Drivetrain - Boom or Drone Noise at 2100 RPM

Bulletin No.: 04-04-17-001B

Date: June 29, 2007

Boom or Drone Noise at 2100 rpm or About 120 km/h (75 mph)
(Inspect and Clean [Torque Tube](#) Mount or Install Dampener/Mount Kit)

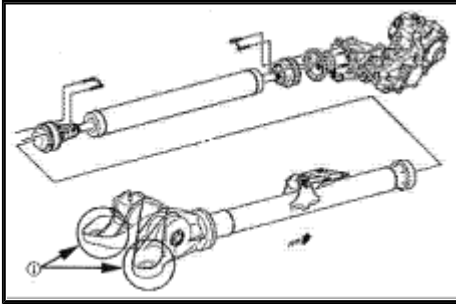
The central [torque tube](#) mount, dampener and bushing may be allowing noise and/or engine vibration to transfer to the body at the mount point.

Vehicles that have been operated on dirt roads or in loose dirt may experience a condition called "mud packing". If a large quantity of dirt accumulates on the center torque-tube mount, noise and/or vibration may be transmitted to the passenger compartment. The illustration above highlights the areas of concern within the circles. Please inspect and thoroughly clean the areas indicated if required. If a quantity of dirt was found on the mount, please road test the vehicle and confirm that the boom or drone noise has been corrected. If the noise remains, continue with Correction # 2.

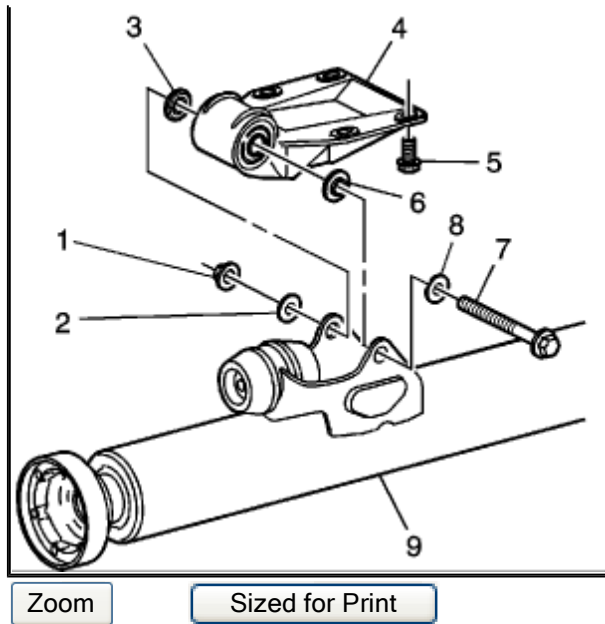
A kit has been developed that includes a revised torque-tube mount, spacing washer and a new dampener. Use the procedure below to install these revised parts.

Loosen the throughbolt (7) holding the [torque tubes](#) to the mount until the nut comes off the bolt. This is a T-47 TORX(R) bolt with a nut (3) on the other end. You will need to hold both ends of the fastener in order to remove the nut. Do not remove the bolt at this point.

Remove the four bolts (5) retaining the [torque tube](#) mount (4) to the floorpan of the vehicle.

Now that the mount is loose, you will be able to slightly raise the [torque tubes](#) (9). This will allow you to remove the throughbolt from the mount by pulling it out over the gas tank. It will require some force to remove the throughbolt, but it should come out with just hand pressure.

Slightly lower the driveshaft. Remove the mass dampener halves from the welded on bracket of the rear [torque tube](#). The dampener is retained by one bolt and nut through the center of the dampener.

bushing/sleeve in the bracket. Remove the captured bushing from the bracket as the rear half of the new dampener will directly insert into the bracket hole.

Install the new dampeners to the [torque tube](#) bracket. The threaded bushing is the rear most half. Install the front half of the dampener, then place (if required) the included washer(s) on top of the dampener, then place the bolt through the washer and dampener halves.

Tighten the dampener retaining bolt to 55 N.m (41 lb ft).

You MUST install the throughbolt with the head of the fastener facing the gas tank. In a collision, the rounded low profile of this fastener presents less chance of damage to the gas tank.

Tighten the [torque tube](#) to bracket throughbolt to 64 N.m (47 lb ft).

Tighten the [torque tube](#) mount to body bolts to 55 N.m (41 lb ft).
